Docket Item # 3 & 4
BAR CASE # 2018-0297
&2018-0298

BAR Meeting
July 18, 2018

ISSUE: Partial Demolition/Capsulation and a Certificate of Appropriateness for Alterations and an Addition

LOCATION: 315 Buchanan Street

Figure 1: Location of proposed addition

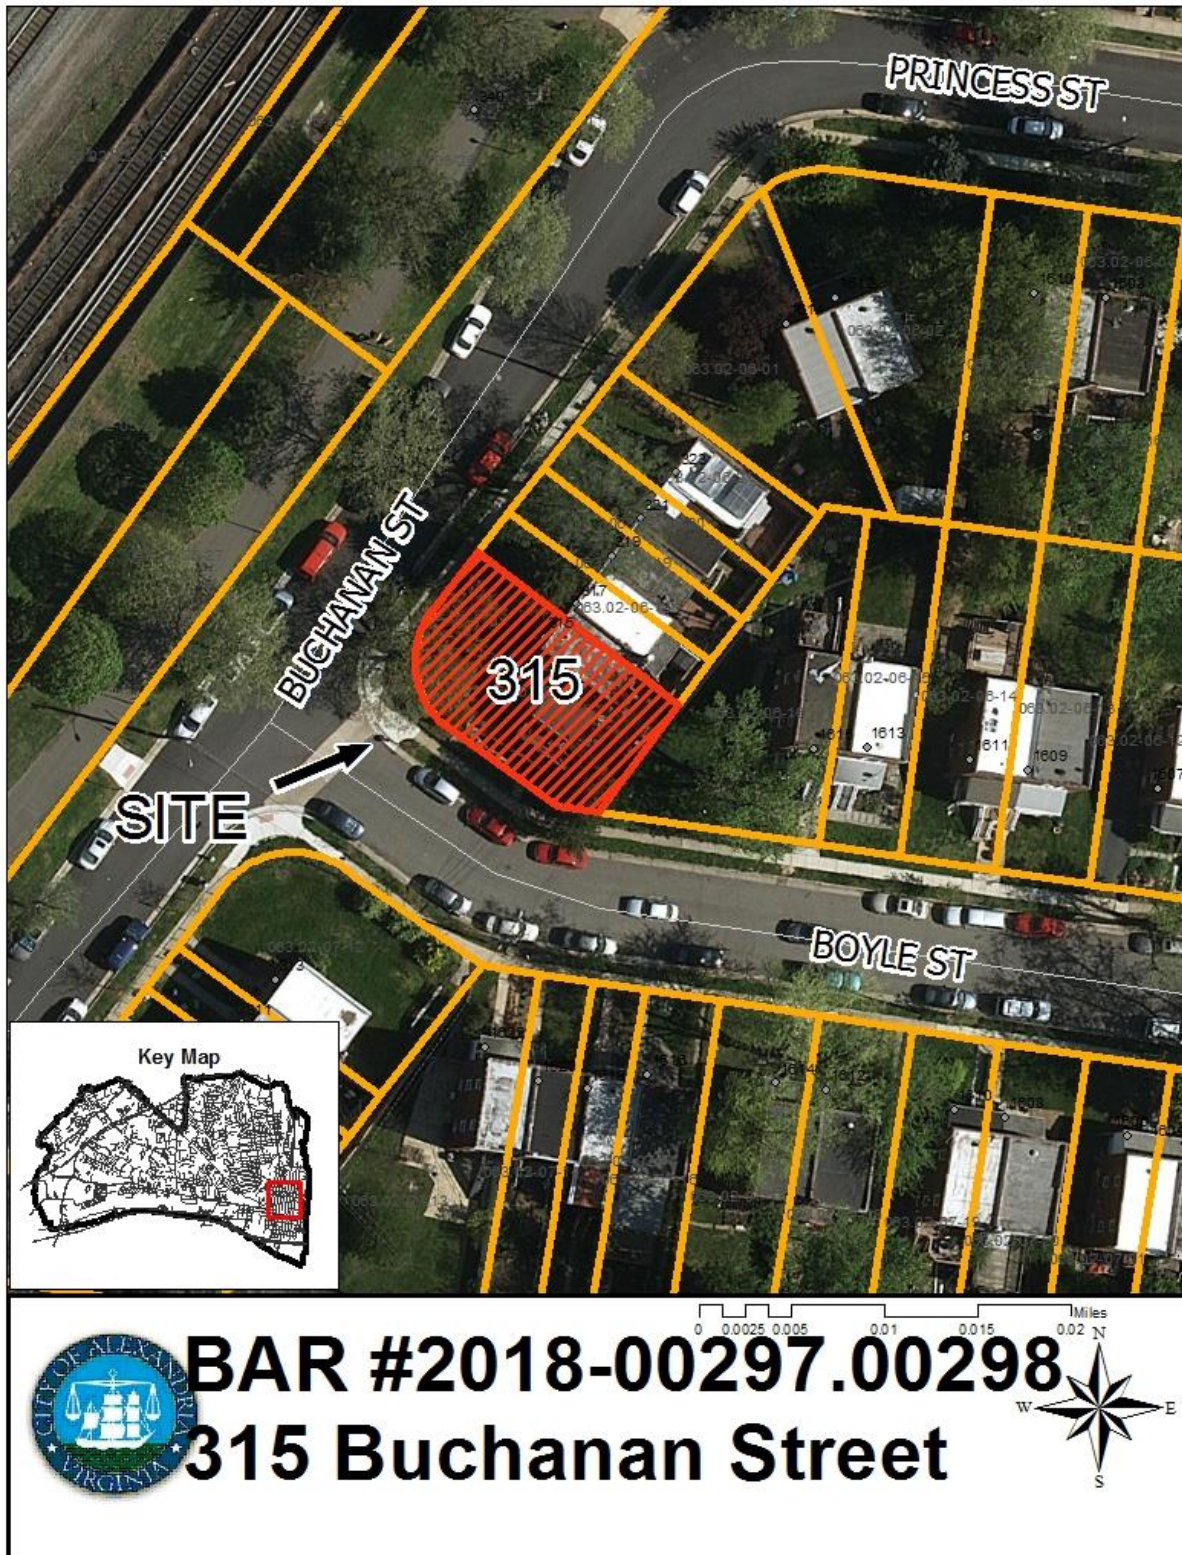
Since the property is a corner lot, the Alexandria zoning ordinance considers this property to have two front yards and two side yards and the proposed addition in the south front yard will be prominently visible from both Buchanan Street and Boyle Street. Section 3-706(A)(1) of the zoning ordinance requires structures in the front yard of the RB zone in the historic districts to be built to "the same as the front lot line or other line consistent with the character of the district that the board of architectural review approves." The BAR has generally considered a setback that was the average of the block-face to be consistent with the character of the district. In this case the historic setback on the north side of Boyle Street is 25' to the masonry portion of the dwellings, consistent with the building line shown on the applicant's survey plat, with an originally open 7' deep front porch. However, this building line is a condition of the original deed of subdivision and is not something that is enforced by the City. The existing two-story addition is setback only 17.2' from Boyle Street and the existing ramp is only approximately 8' from the front lot line. The proposed 6'-6" x 12'-0" deck will be elevated approximately 6' above the grade in the front yard and the set back will increase slightly to 10.7 feet from the front lot line. The BAR must make a finding that the front yard setback of the proposed 3-story addition and second floor deck are appropriate in this location.

The *Design Guidelines* state that an addition to a historic building should be clearly distinguishable from the original structure. The new construction will be set back approximately two feet from the west front of the original brick building and will have fiber cement clapboard siding on the first and second stories, in contrast to the red brick on the main house. The basement level will have a concrete block wall to match the existing basement level, with the exception of the Buchanan elevation where it will be clad with brick to match the façade of the original dwelling. The second-floor covered balcony on the south elevation will add visual interest and break up the overall massing of the addition.

4 ROOF PLAN - PROPOSED
A001 SCALE : 3/16" = 1'-0"

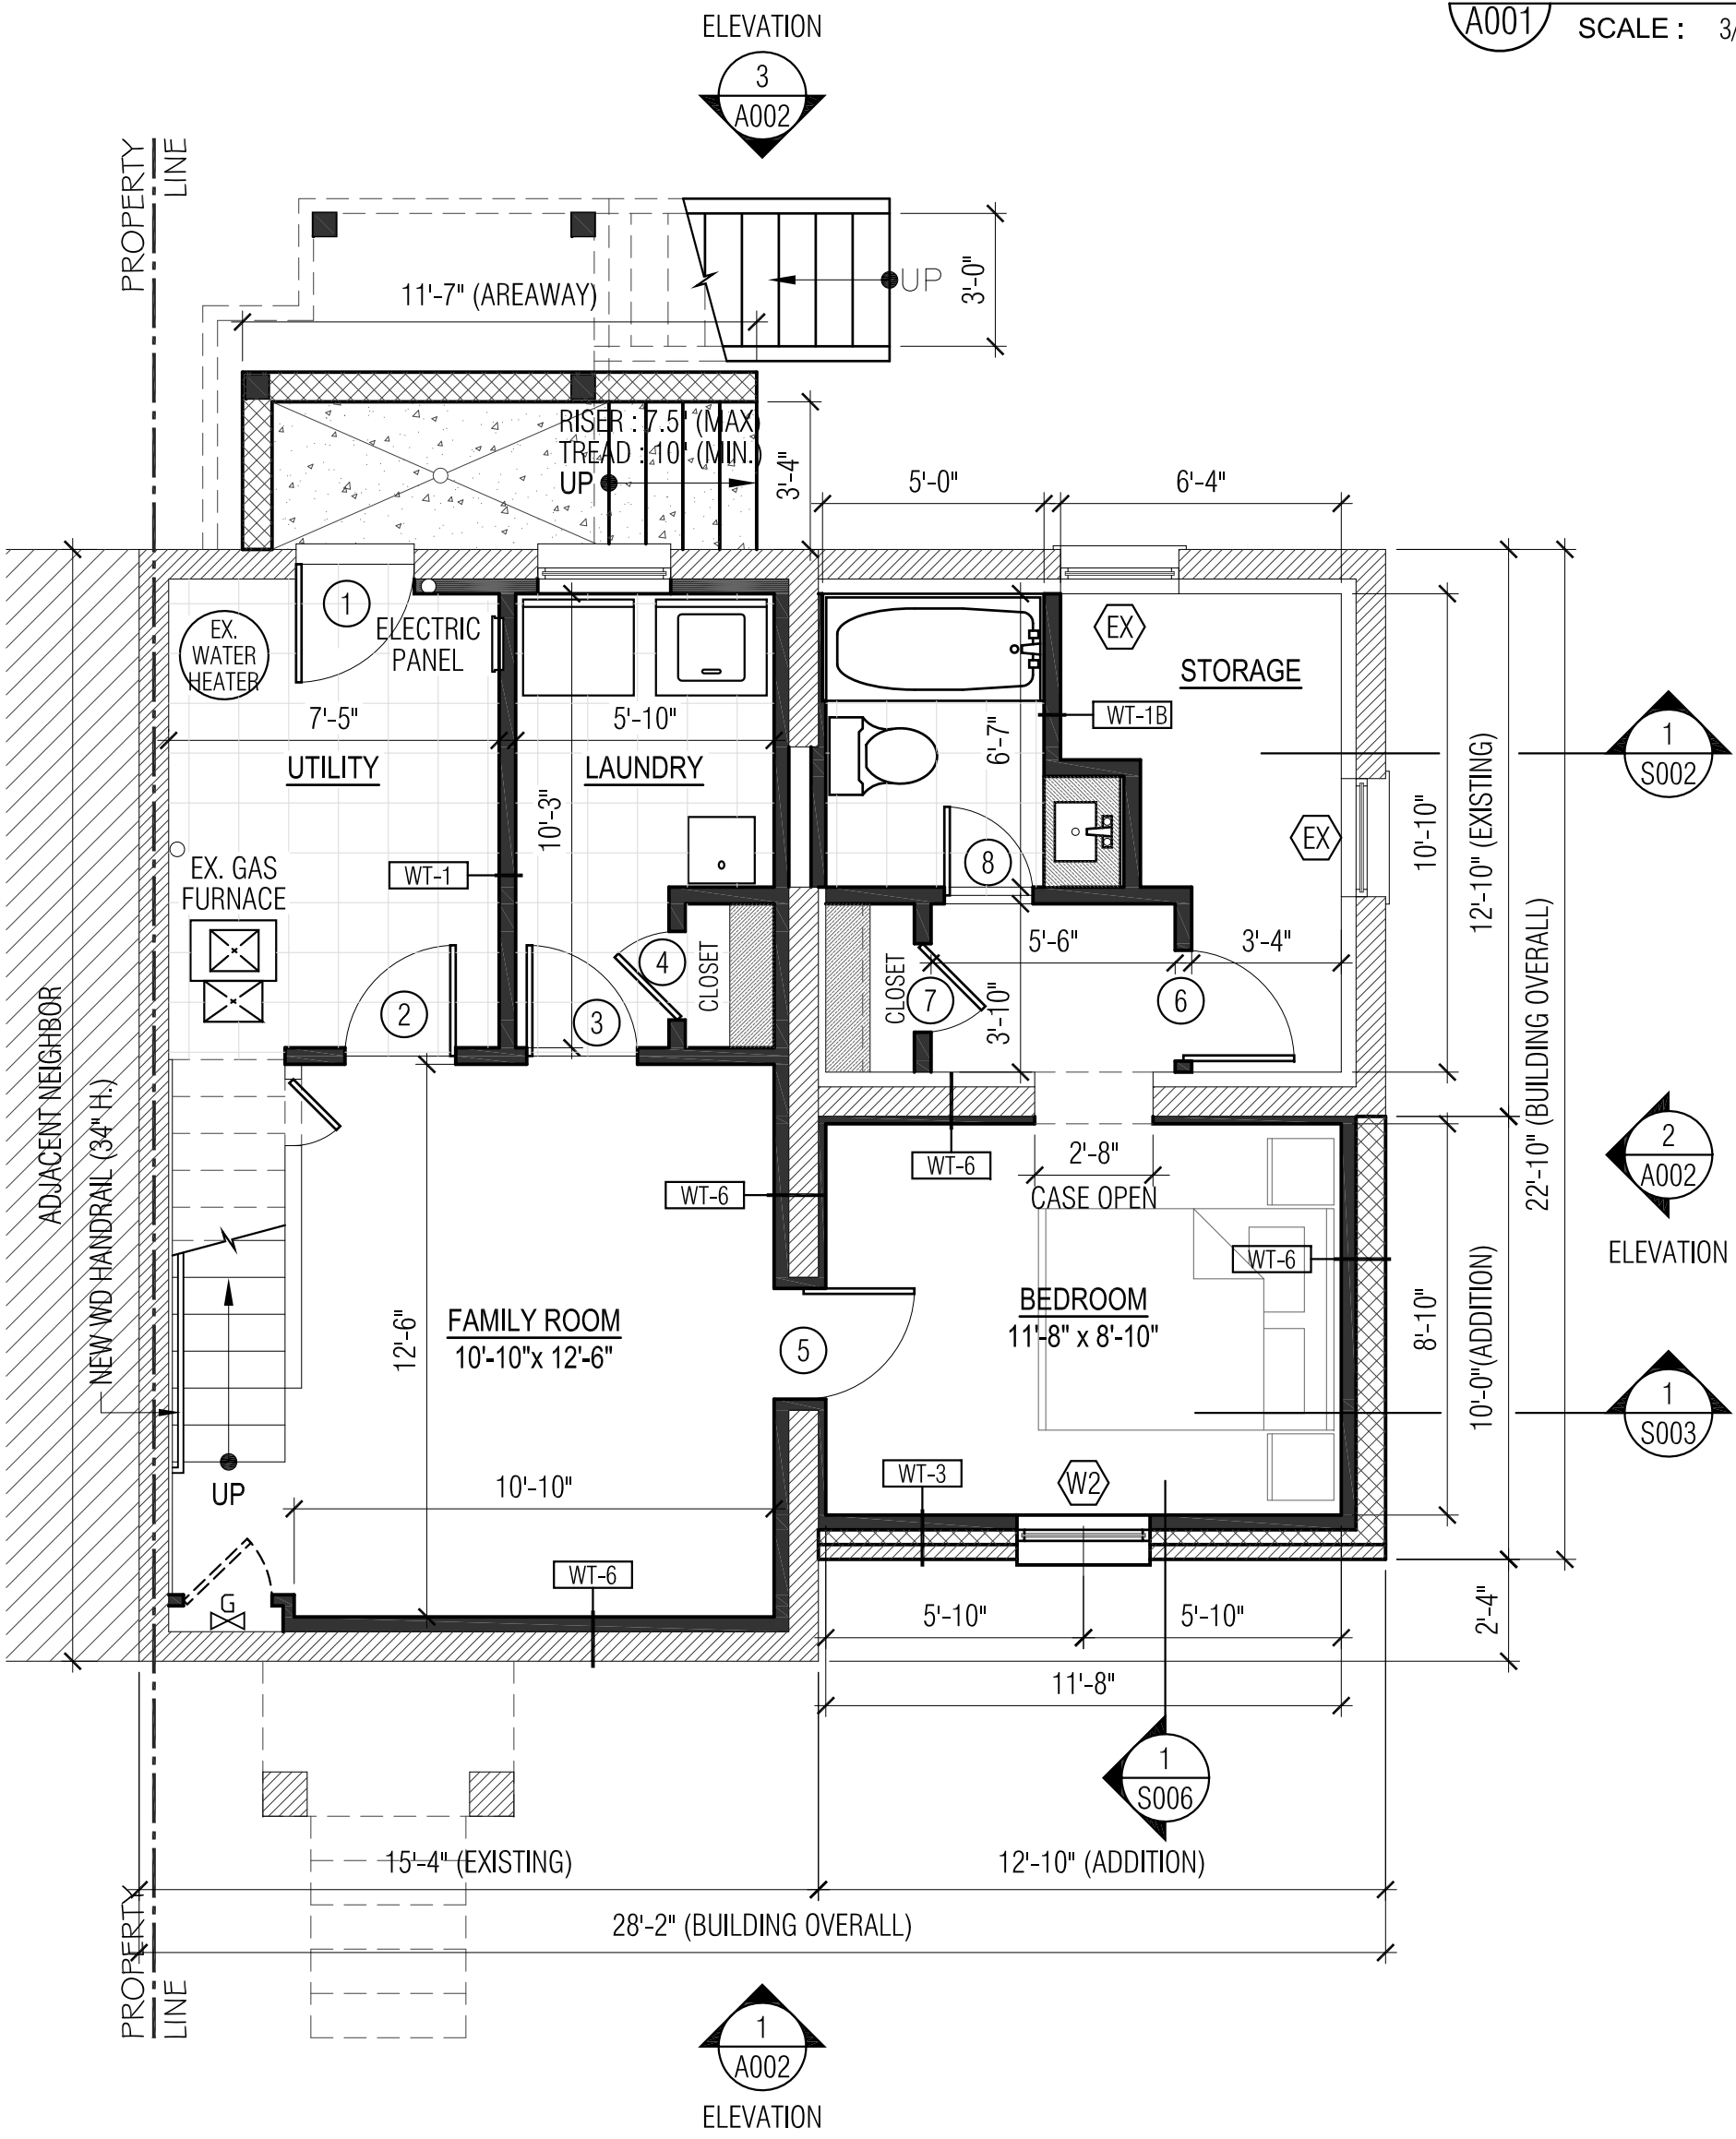
3. Locate the rooftop HVAC condenser near the center of the existing dwelling east/west and toward the north side of the roof as much as possible to hide its visibility from Boyle Street and run all refrigerant and electrical lines internal to the dwelling rather than on the exterior face of the dwelling.

The proposed roof plan drawing #4 on sheet A001 indicates a "new condensing unit" on the flat roof of the existing dwelling. The Goodman GSX14 condensing unit is approximately 36" tall, plus the height of the base. The existing parapet is shown on the wall section drawing on sheet S003 is approximately 8" tall, so the unit will very likely be visible from a public way, particularly when viewed from the east on Boyle Street. The applicant has not indicated any screening, as required by the zoning ordinance, or requested a waiver from the BAR for such screening. However, staff recommends that the BAR approve a waiver in this instance, provided that the unit is located near the center of the dwelling east/west and is pushed toward the north side of the roof as much as possible to hide the view from Boyle Street and that all refrigerant and electrical lines are run internally.

5 FENCE DETAIL
S006 SCALE : 3/8" = 1'-0"

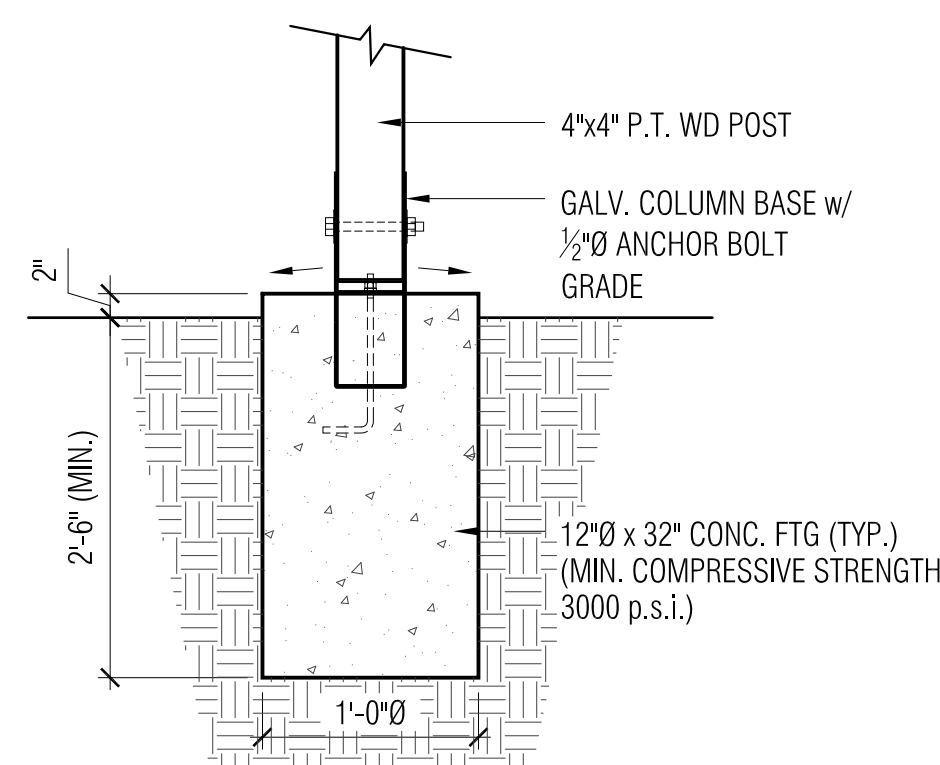
2. The replacement fence on the east property line must be the same design and 7' total height as the existing fence and the 7' height may extend no farther south than the face of the existing addition.

In 2011, following extensive discussion, the BAR approved a waiver of fence height for a 6' tall wood fence topped by a 1' tall lattice on the east property line not to extend further south than the face of the existing one-story addition. The present application requests replacement in-kind but detail #5 on page S006 of the drawings indicates a 6' tall fence topped by 24" of pressure treated lattice. Staff supports replacement in-kind of the existing 7' tall fence in the same location but recommends denial of the request to increase the height of the existing fence, finding no compelling topographic reason to support a height increase in this location.
